OSCILLOSCOPES PM3262 – PM3263

Subject : CRT with quick heating cathode (D14 – 302GH/93)

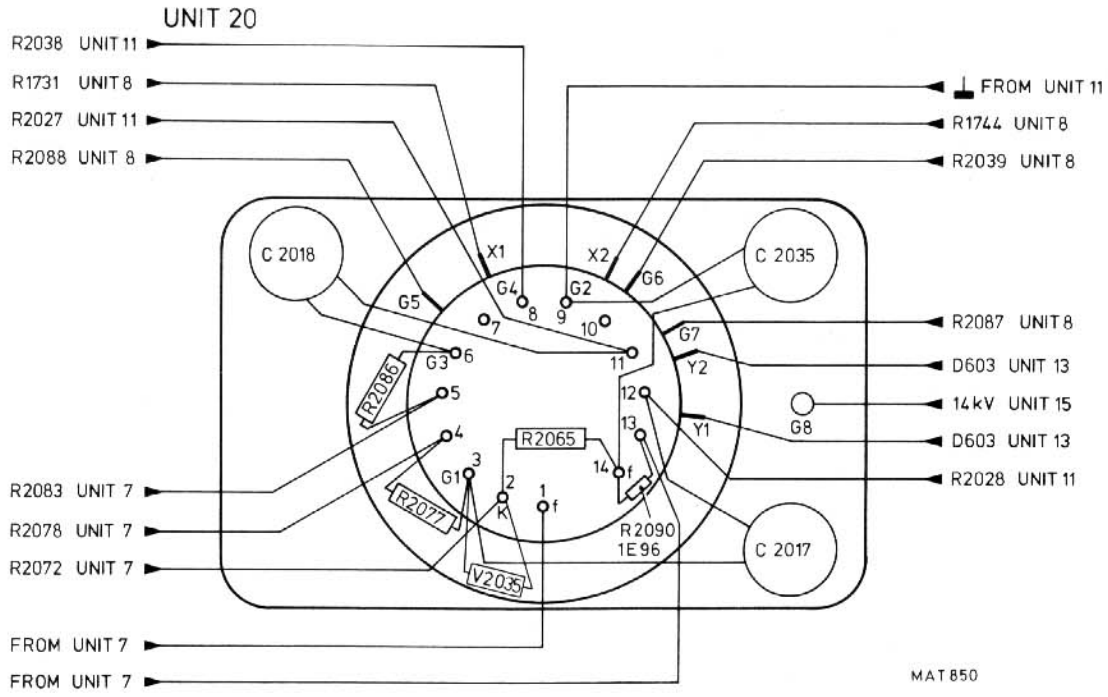
Starting with the PM3262/07 and the PM3263/03 CRT's with a quick heating cathode (D14 – 302GH/93) are mounted in the instruments.

If such CRT's are used as replacement tube for PM3262/01/..../06/ and for PM3263/01/02/ instruments, these instruments have to be modified in the following way.

- Wire on point 14 of the CRT socket must be disconnected from point 14 and soldered on point 13.
- A resistor R2090 of 1,96 Ω– MR30 – ½% must be added between the points 13 and 14 of the CRT socket (see figure)
